TECHNICAL MEMORANDUM

DATE: August 14, 2023
TO: Erin Stevens, Town of Concord
FROM: Julie Dombroski, Boston Region MPO
Casey Cooper, Boston Region MPO
Rebecca Morgan, Boston Region MPO
RE: Community Transportation Technical Assistance (CTTA) Program:
Route 2 Crossings in Concord

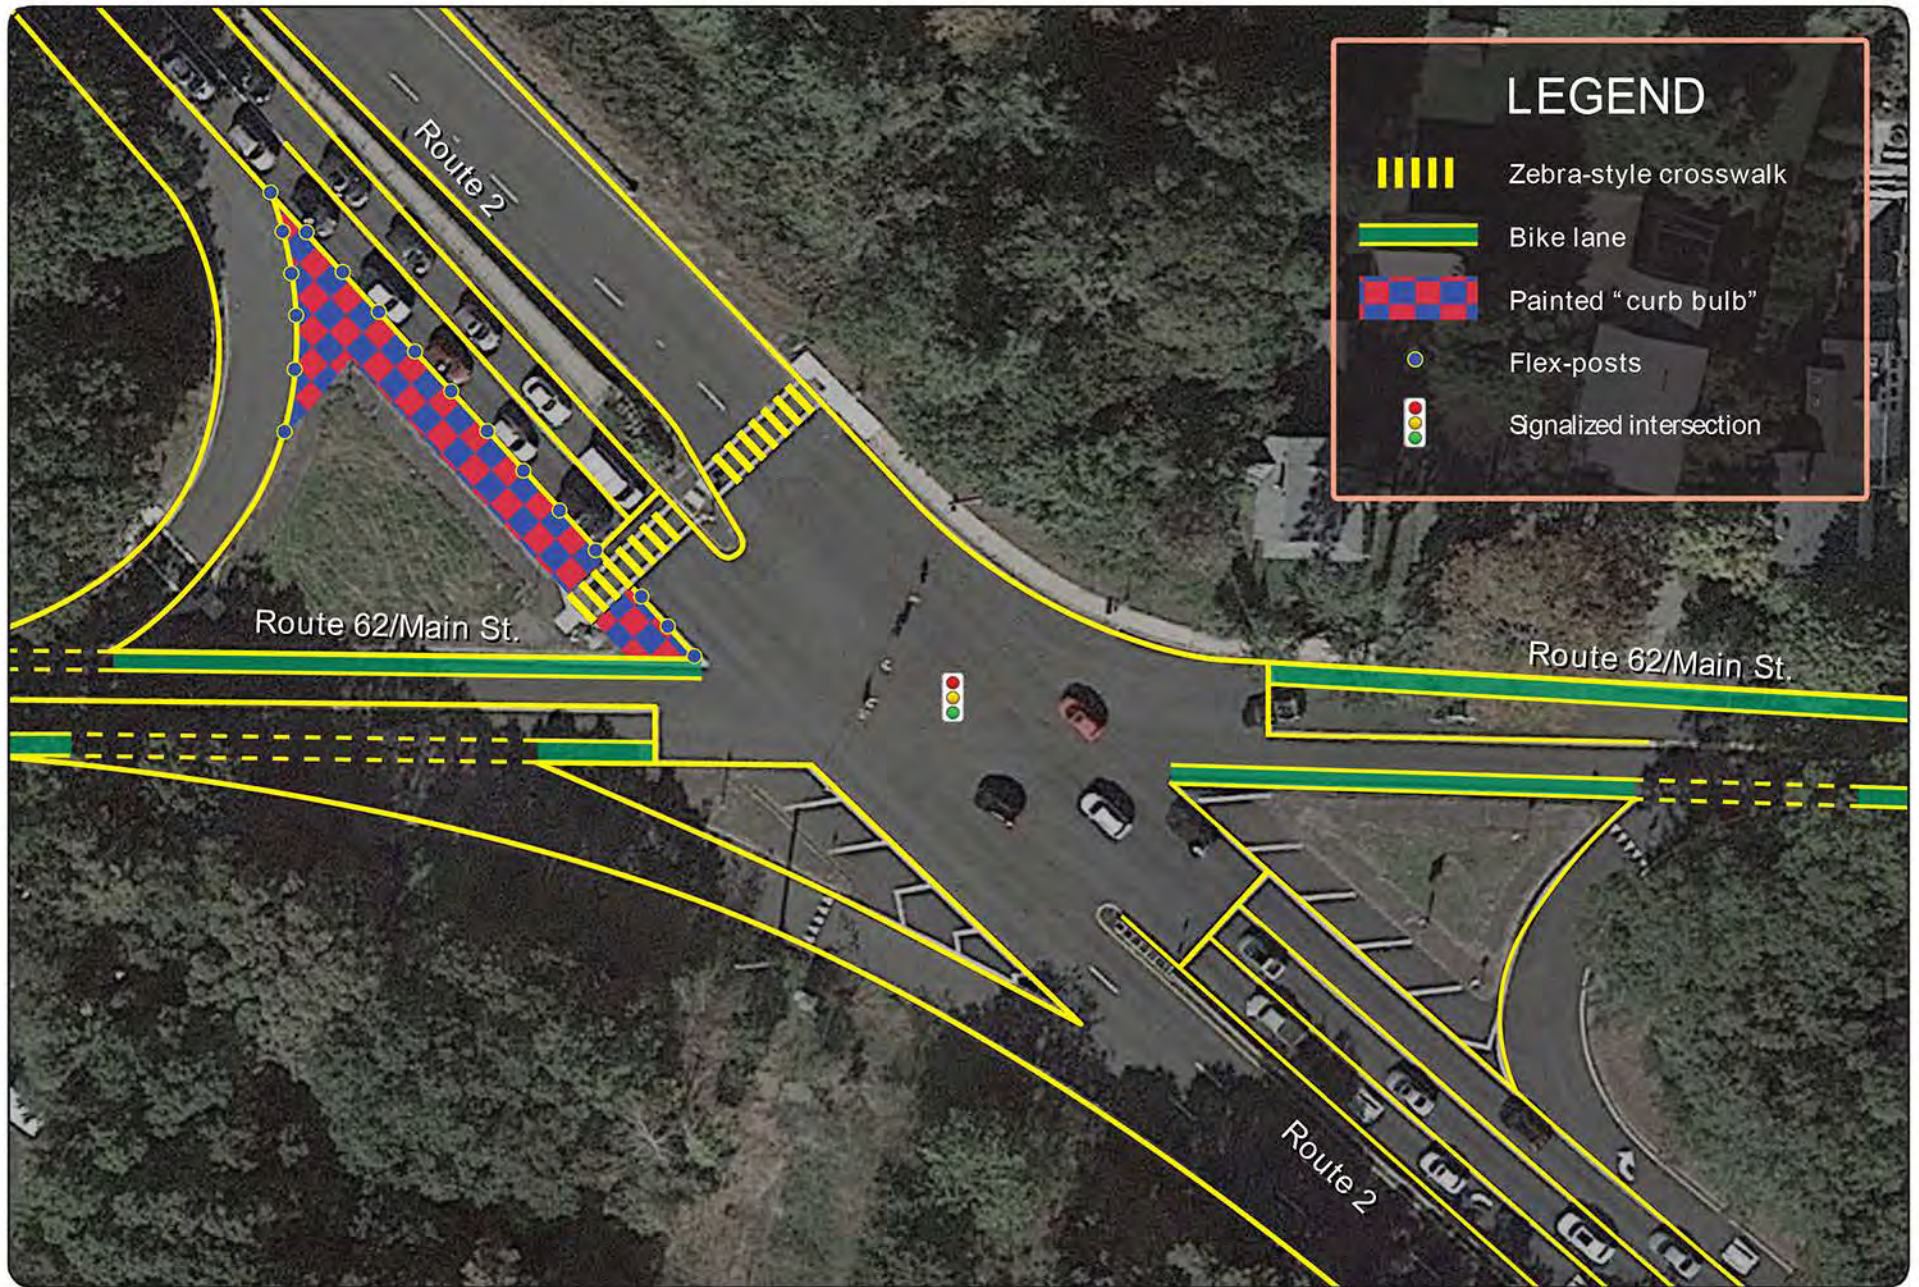
After review of the proposed interventions, Town of Concord Engineering department suggests bolstering the proposed painted pavement with temporary curbs. They also recommend that further work be done to improve the slip ramp crossing.

15	2 at 62	Flex posts are not recommended on high speed roads such as Route 2 due to maintenance concerns.
15	2 at 62	All proposed mitigation shall be MUTCD compliant. (Figures 8/9)
16	Figure 8	Relabel "Zebra striped" pavement is to 'hatched gore'.
16	All	Buffers should be considered for all bike lanes proposed on high speed/high volume roadways to provide safe passage for bicycles.
19	2 at ORNAC	Backplates with retroreflective boarders exist at this signal and can be seen in the photo on page 6 of this report.
19	2 at ORNAC	Provide pedestrian clearance calculations to support recommended pedestrian time extension.
26		Include the name of the intersection which need pedestrian signal indicators replaced in last bullet.

FIGURE 17
An overview of short-term improvement alternatives
at the intersection of RT 2 and ORNAC.

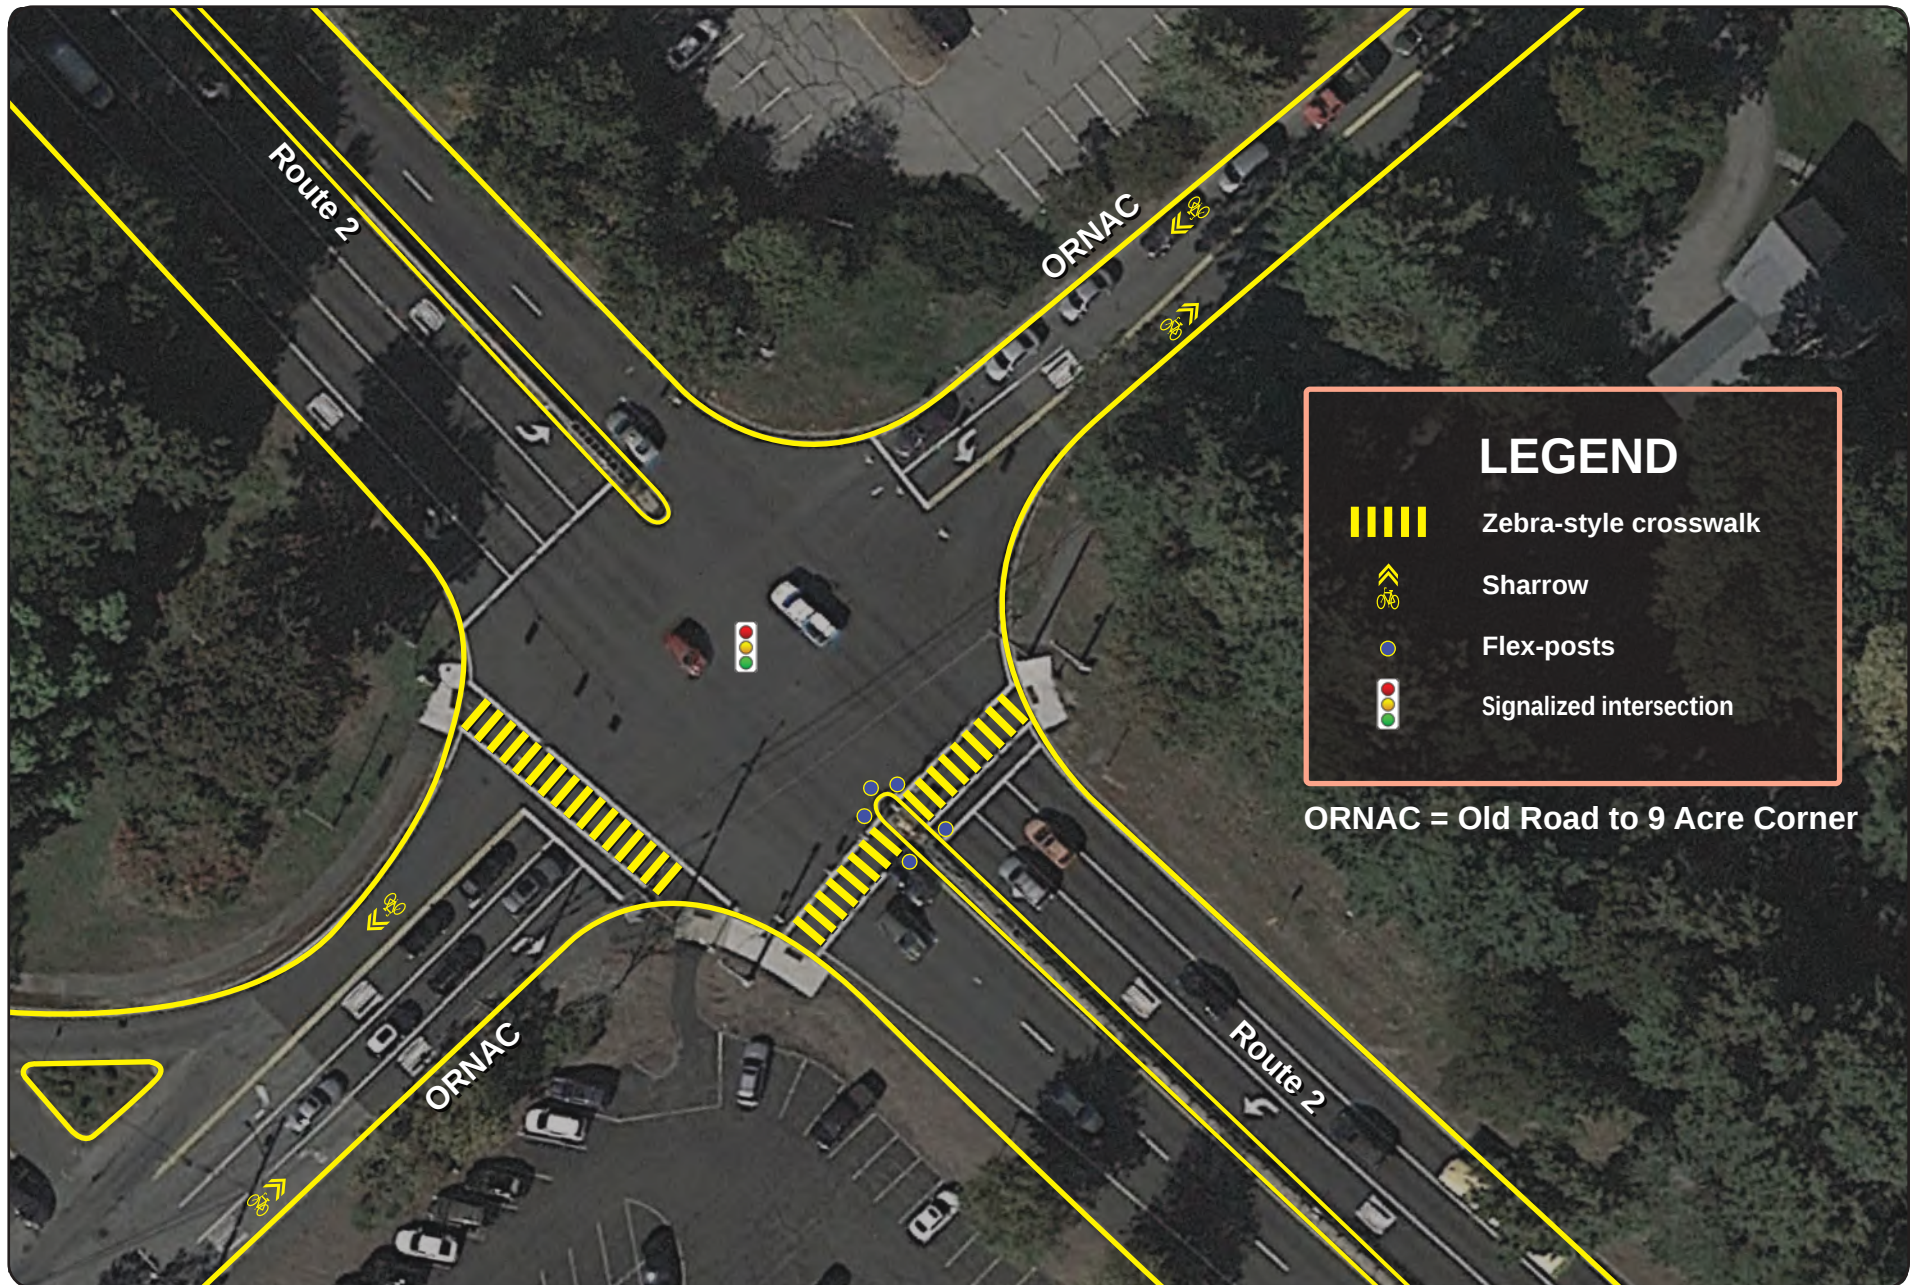
The Town Engineering Department commented that the median sign at the intersection is missing and that further work should be done to improve bicyclist safety at the intersection of ORNAC and Old Marlboro Road.

Page	Location	Comment
4/26	2 at ORNAC	Please re-check field conditions at intersection. All pedestrian buttons at this location are currently ADA accessible. The pedestrian crossing phasing at this intersection was recently updated and a pre-empt was installed which prioritizes pedestrian calls across Route 2.
10	2 at 62	Provide observed speeds on Route 62 and ORNAC in existing conditions narrative.
12/13	All	As the purpose of this effort was to document pedestrian safety, pedestrian counts should be provided in the report. Show pedestrian counts on Figures 6 and 7.
12/13	All	Weekday evening peak hours generally occur between 4-6pm, however the study is showing the evening peak hour starting at 2:30/2:45pm. Why is the evening peak hour so early? Please provide raw traffic counts in the appendix and double check peak hour of roadway.
14	All	Show V/C ratio in capacity analysis summary table.
15	2 at 62	Provide pedestrian clearance calculations to support recommended pedestrian time extension.
